**JINDAL ALUMINIUM LTD.**  
 BANGALORE-560073 (INDIA)

NAME	DATE
DRAWN	J.P.KAUSHIK	22-03-2013
CHECKED		
APPROVED	S.S.GARG	25-03-2013
SCALE		1:1
AREA mm <sup>2</sup>		181.74
PERIMETER mm.		194.91
WEIGHT kg/m		0.491
DRAWING No.	SECTION No.	
P-12581	-	
S3694	S3694(ISSUE-4)	
22935	22935

PARTY'S NAME	SRINATHJI ALUMINIUM ENTERPRISES, CHENNAI
PARTY'S DRAWING No.	SAE-LOUVER-DIE-DRG-003
ALLOY & TEMPER	HE9 WP
DESCRIPTION	MISC. SECTION

P-12581

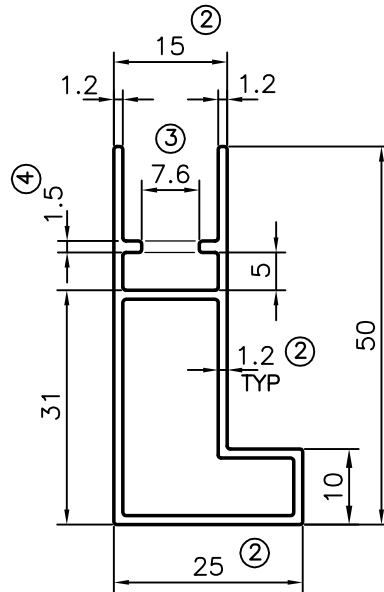
DIMENSION CHANGED FROM 22 TO 25 WALL THICKNESS CHANGED FROM 0.8 TO 1.2 mm  
 DIMENSION CHANGED FROM 12 TO 15 & FROM 1.5 TO 2.5 mm & OTHER DIMENSION  
 CHANGED ACCORDINGLY

DIMENSION CHANGED FROM 11 TO 7.6

DIMENSION CHANGED FROM 2.5 TO 1.5
